TRAVERSING IN-CORE PROBE SYSTEM

LIMITING CONDITION FOR OPERATION

3.3.7.7. The traversing in-core probe system shall be OPERABLE with ~~X~~ either:

CORE POSITION MAP

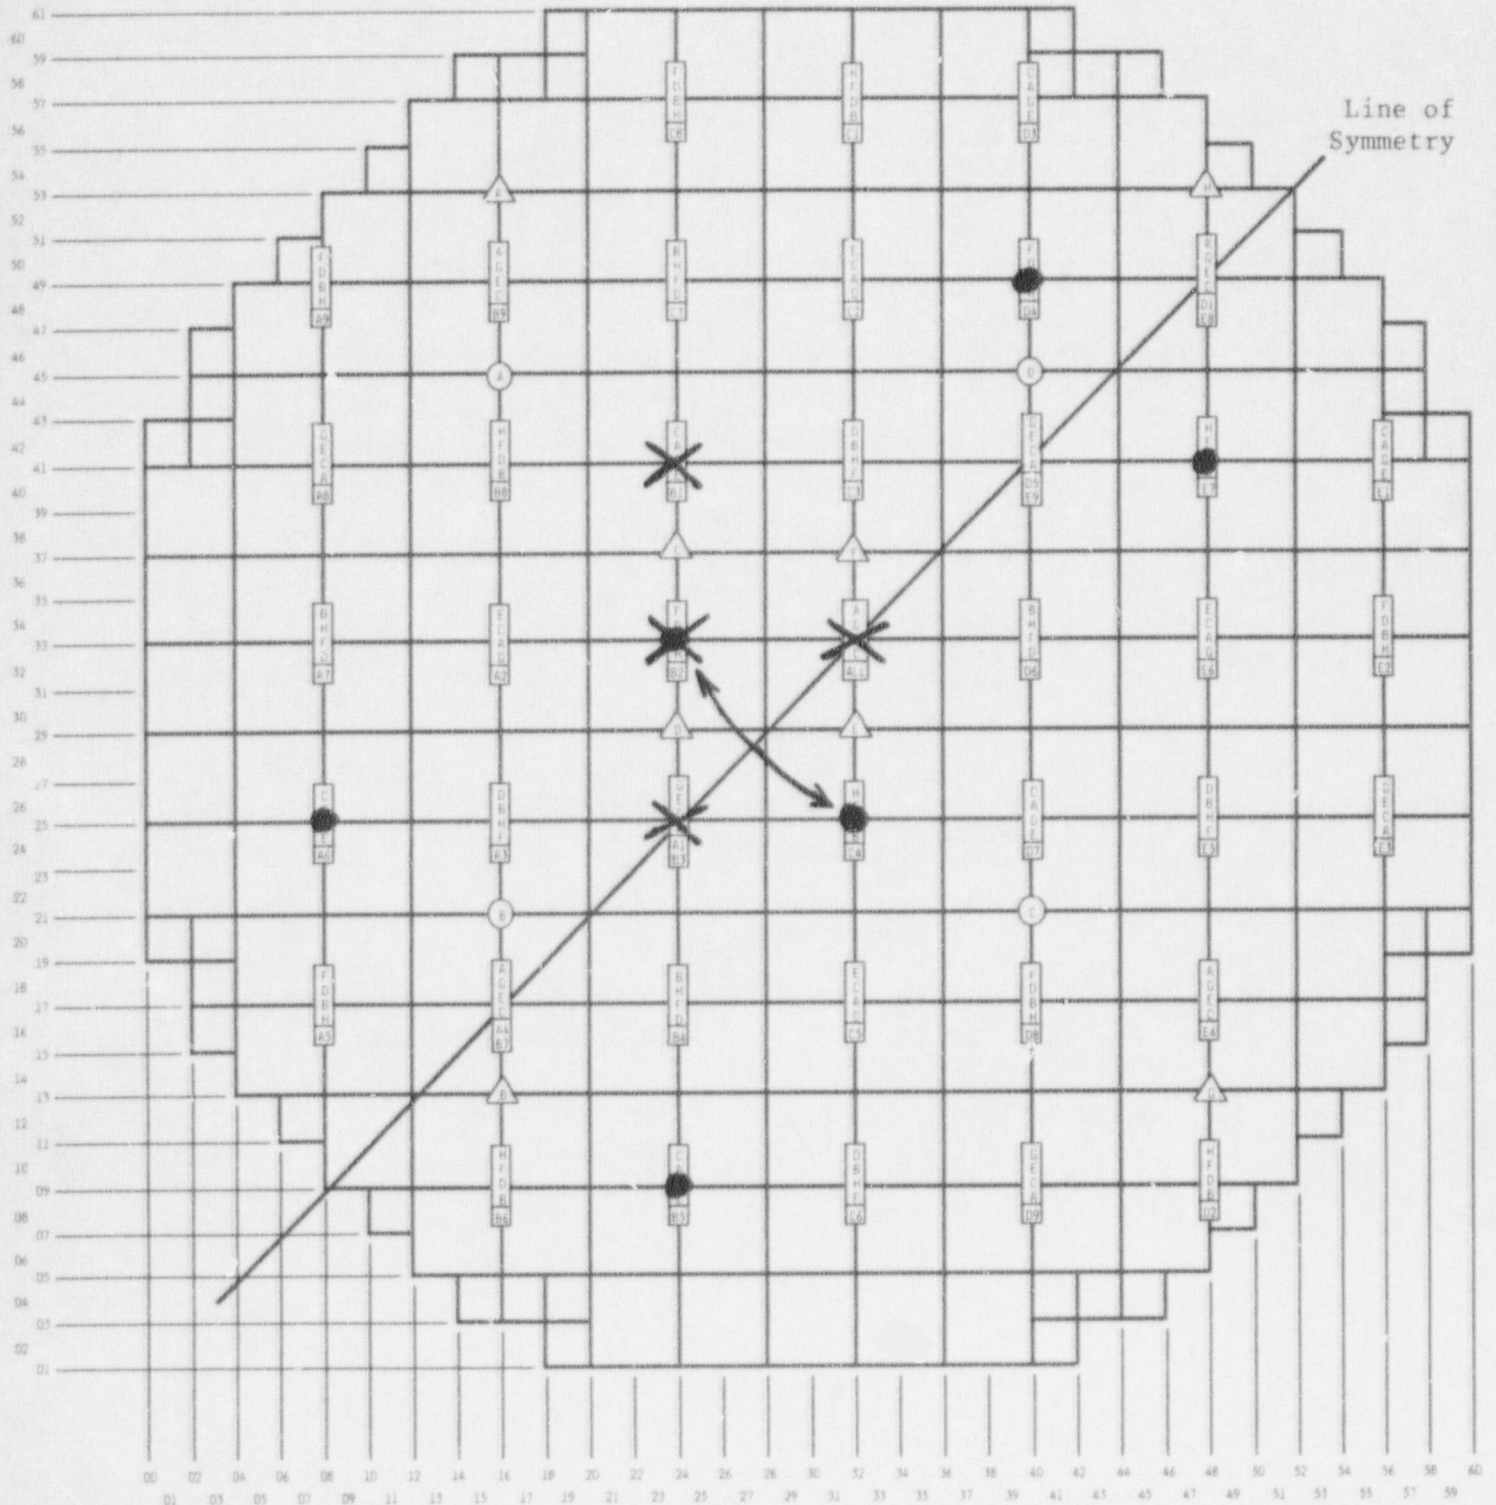
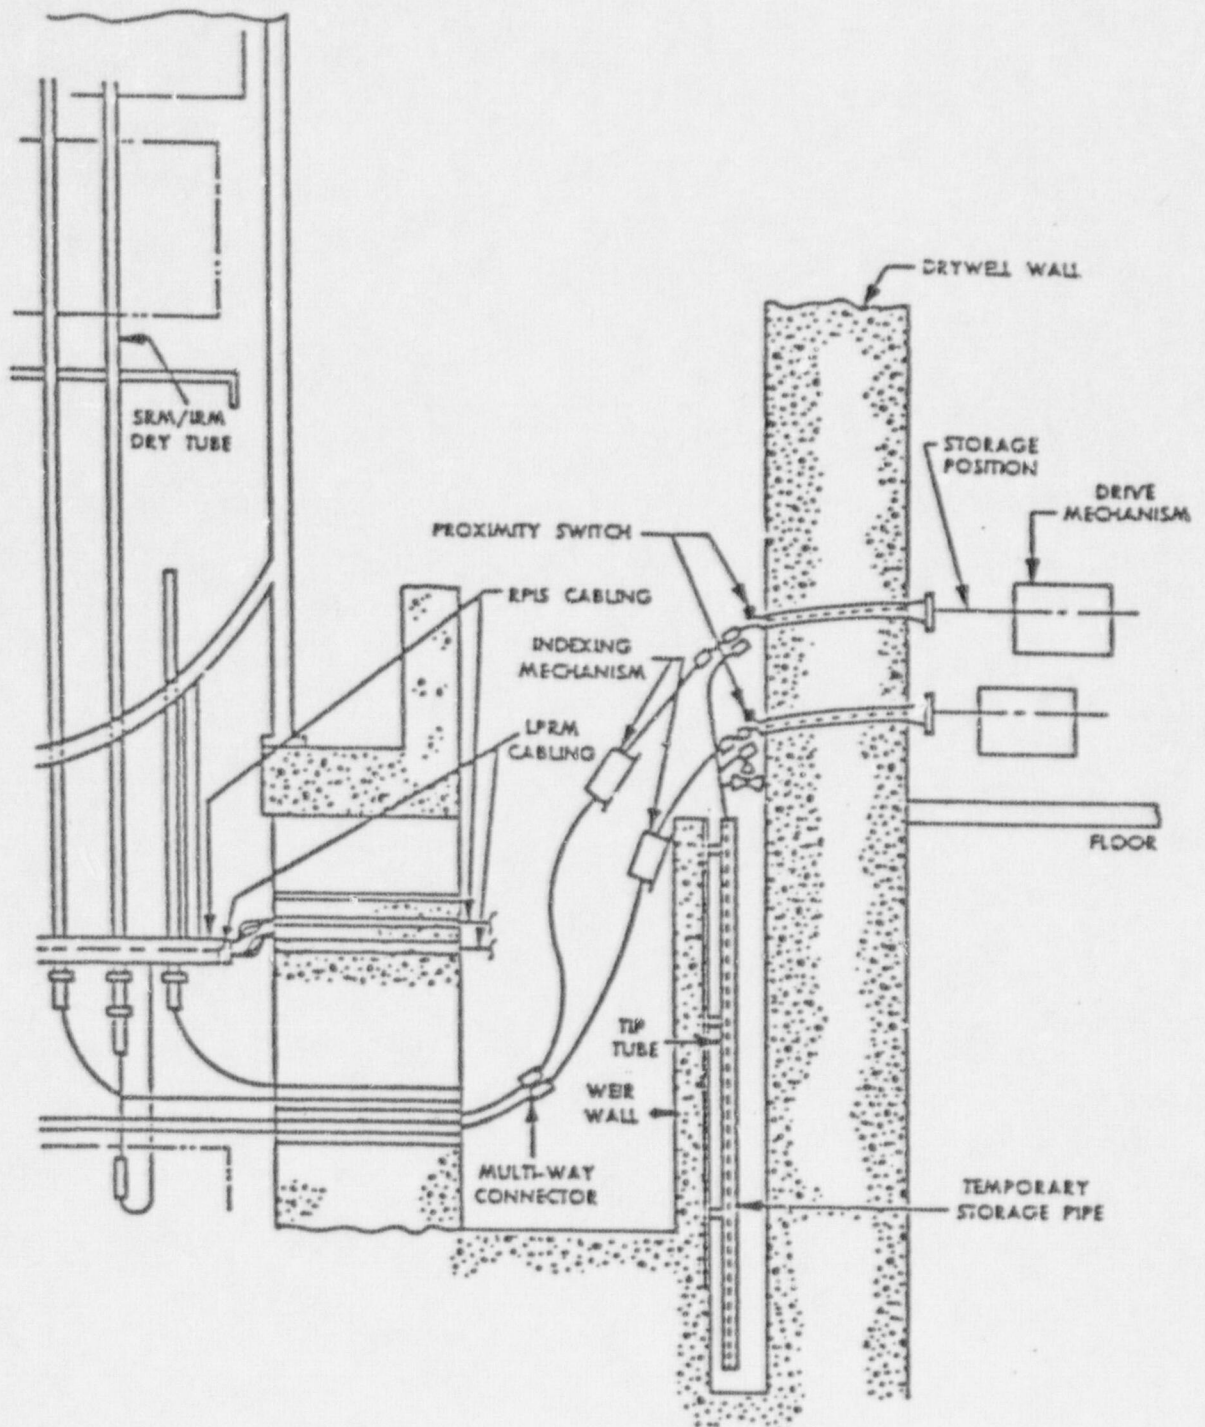
With less than the specified complement of equipment, the spatial gamma flux distribution of the reactor core can still be accurately represented by using replacement data from symmetrical strings (LPRM locations), provided the conditions specified in the LCO are met.

X - inaccessible locations to
B TIP machine

● - examples of symmetric LPRM locations
